State of Alaska
Department of Environmental Conservation
Village Safe Water Program

Re: Amendment 4
ITB 22-VSW-UNK-039
Pipe Order
ITB Due Date: March 30, 2022 @ 2:00 PM AST

BID SCHEDULE ITEM A

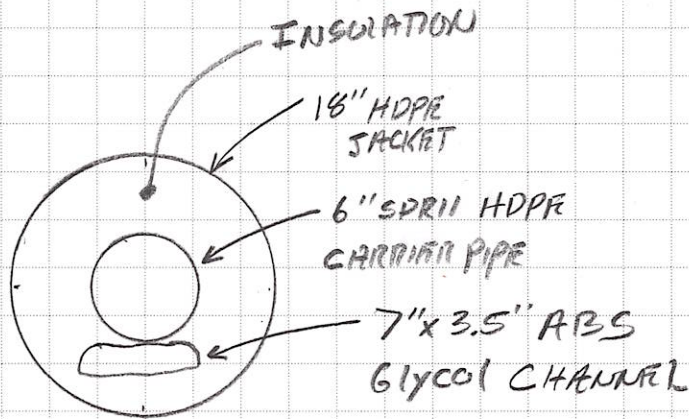
1. Vendor: I am working on this ITB for us and had a few questions on the bid schedule if you could clarify?
 - Bid Schedule Item A – 6" x 18" HDPE Jacketed Arctic Pipe

- This would be **Detail 1 Raw Water Pipe** shown below with 18" HDPE outer jacket and 6" HDPE Raw Water Pipe
- Bid Schedule Item C – 6" x 15" HDPE Jacketed Arctic Pipe
 - This would be **Detail 1 Raw Water Pipe** shown below but with 15" HDPE outer jacket and 6" HDPE Raw Water Pipe?
- Bid Schedule Item F – 6" x 15" Aluminum Jacketed Arctic Pipe
 - This would be **Detail 2 Raw Water Service Pipe** with 15" Aluminum outer jacket and 4" HDPE carrier pipe/2" HDPE main pipe – per the note in the table for "Raw Water Well Line"?
- Bid Schedule Item G – 6" x 18" Aluminum Jacketed Arctic Pipe
 - This would be **Detail 2 Raw Water Service Pipe** with 18" Aluminum outer jacket and 6" HDPE carrier pipe/2" HDPE main pipe – per the note in the table for "Raw Water Main (Above Grade)"

Department: Please see attached pipe sketches and bid schedule.

BID SCHEDULE ITEM C

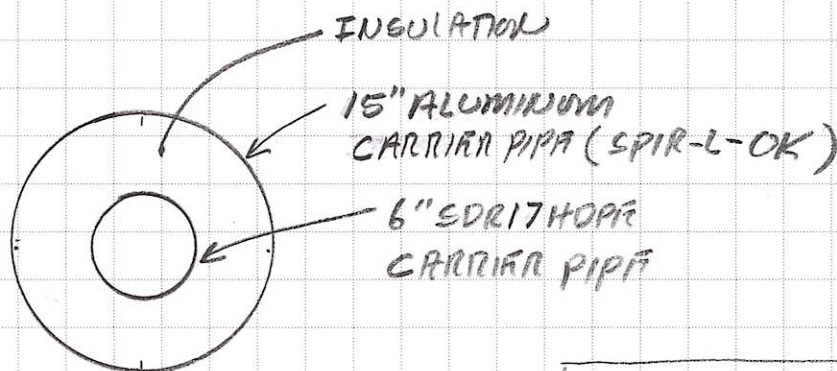
NOTE: RE-NAME BID ITEM C
TO 6x15 ALUMINUM
SACKETED ARCTIC PIPE.
